April 5, 2022

Gretchen Milliken, Planning Director
Park City Municipal Corporation
Marsac Avenue, PO Box 1480
Park City, UT 84060

Overview of Park City Mountain/SE's CCC Calculations

Analysis of PCMR/ SE CCC Calculations

**Assumed Location of New Eagle lift (magenta Line)
(Mid-station unload near top of Three Kings)**

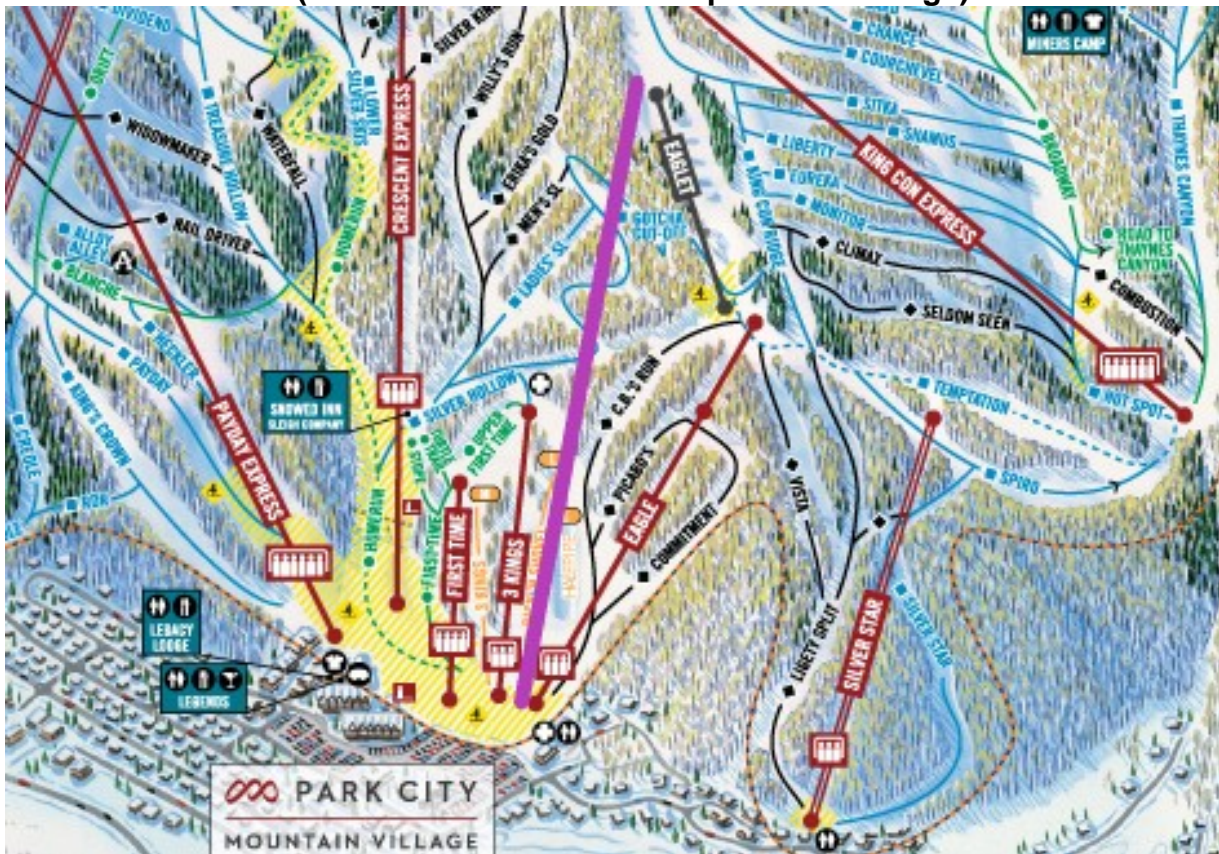
PCMR proposes to install a new Eagle lift that generally goes from the existing bottom of Eagle to the ridge near the top of the Eaglet lift, with a mid station offload located near the top of the existing Three Kings lift. Both the existing Eagle and Eaglet lifts will be removed. According to the application memo, the new Eagle lift will function as a staging lift in the morning and for return cycle skiing on the trails currently served by the Three Kings lift (and assumably, as a return cycle skiing lift for trails coming off the ridge on the terrain spanning from Commitment to Men's & Ladies' SL). The CCC table shows a large adjustment for transportation functions, which makes sense. This is assuming that the lift is proposed largely for staging in the morning, and will run less than full during the rest of the day due to the fact the higher capacity has been chosen primarily to efficiently stage people out of the base area more quickly in the morning (to reduce lift lines at the base area). The one number that does seem to be out of place however, is the VTF demand assigned to this lift. As listed in the table, the VTF demand on this new Eagle lift is 19,087 Vertical Transport Feet/Day, which is appropriate for a lift that services black diamond terrain.

However, as described in the application memo, this new lift alignment now services a combination of black diamond, blue and green terrain, which means that the average VTF demand per skier on this lift should drop dramatically; our estimate is that the VTF demand on this lift would likely shift to the 12,000 to 13,000 Vertical Transport Feet/Day range based on the mix of trails serviced by the new Eagle lift. If we use the 13,000 Vertical Transport Feet/Day figure, then the calculated CCC of the new Eagle lift would be approximately 850 skiers per day (270 higher than the 580 calculated on the table included in the application).

In the application memo, PCMR/SE has argued that the combined CCC in this zone would increase by a total of approximately 120 skiers per day as a result of the installation of the new Eagle, the removal of the old Eagle, the removal of the Eaglet, and the reduced utilization of the Three Kings chair due to the attractiveness of using the bottom section of the new Eagle as a return cycle skiing lift on the Three Kings terrain.

The recalculation of the Eagle CCC using the adjusted VTF number as shown above would increase the mountain's total CCC by approximately 270; higher than the number provided in the application table (from 12,860 to 13,130 Vertical Transport Feet/Day). While we believe that a reduction in the CCC assigned to Three Kings makes sense due to the competition from this new high capacity and easier loading lift, we believe that the reduction may actually be understated. If the lower section of Eagle does in fact service exactly the same terrain as Three Kings (we assume so from descriptions from PCMC, as we have not received a plan showing its exact location) we could imagine a situation where the existing Three Kings lift would basically go unused during the bulk of the day, due to the attractiveness of the new Eagle lift. If this does happen, then we can imagine that the lift company would choose not to operate that lift (as it would be running empty) and therefore its CCC would effectively be zero. In that case, the overall Mountain CCC, with Eagle at 850 and Three Kings at 0, would be almost identical to that in the application table (12,850 vs 12,860).
